WATER QUALITY MEMORANDUM

Utah Coal Regulatory Program

March 11, 2013

SUBJECT: 2012 3rd Quarter Water Monitoring, Andalex Resources, Centennial Mine, C/007/0019, Task ID #4168

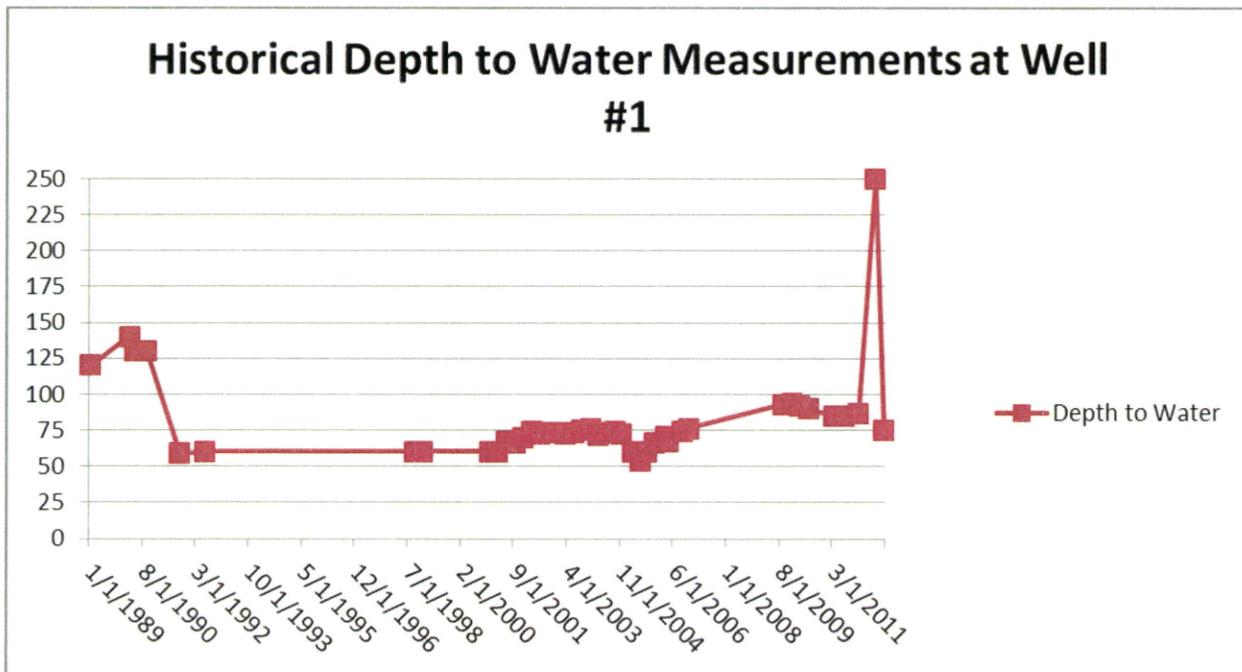
Wells

None. Depth to water levels measured averaged 75 feet, which appears to be consistent with data from previous year's seasonal data. The 250 reading from second quarter was an erroneous measurement.
